HISTORIC AND DESIGN REVIEW COMMISSION

August 03, 2016 Agenda Item No: 20

HDRC CASE NO:	2016-295
ADDRESS:	722 S ST MARYS
LEGAL DESCRIPTION:	NCB 902 BLK LOT 24 AT 724 ST MARY'S
ZONING:	IDZ H HS
CITY COUNCIL DIST.:	1
DISTRICT:	Lavaca Historic District
LANDMARK:	El Mirador
APPLICANT:	Robert Alvarado/Alvarado Builder
OWNER:	Sendero Ranch Development LTD
	Sendero Ranch Development LTD Installation of entry canopies, window awnings, fencing and entry tile

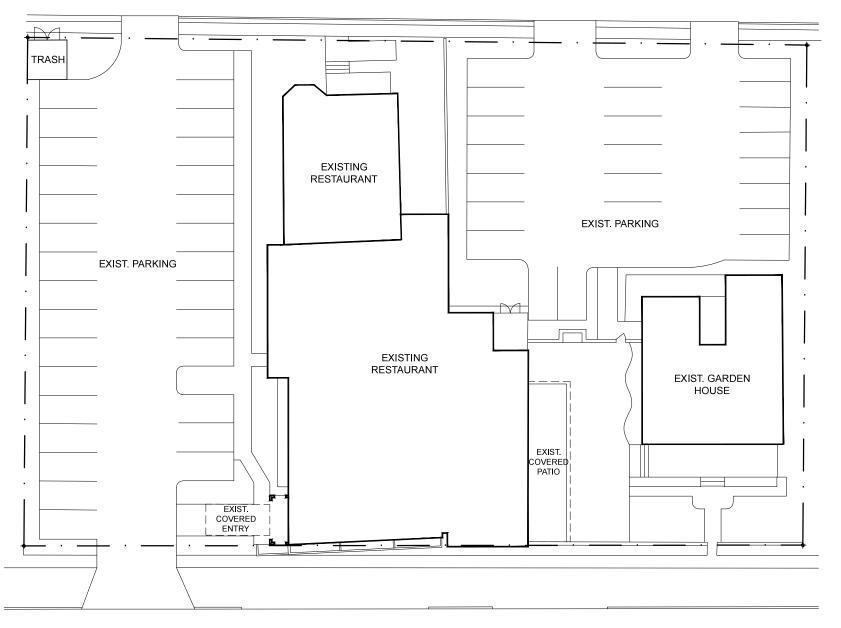
- e. Currently, a wrought iron fence exists in the front yard of the King William Garden House. At the July 15, 2015, HDRC hearing, a new stone wall was approved to replace the existing wrought iron fence. At this time, the applicant has proposed to modify the previous approval to install a 42" tall "coyote fence". According to the Guidelines for Site Elements 2.B., New fences and walls should appear to be similar to those used historically within the district, should be no taller than 4 feet in the front where seen from the public right of way and should be constructed of appropriate materials. Staff finds that there is no precedent for the proposed coyote fence to be installed as the primary front yard fence for a historic structure of the Folk Victorian style. Staff recommends the applicant either retain the existing wrought iron fence or construct the previously approved stone wall.

Staff does not recommend approval of item #4 based on finding e.
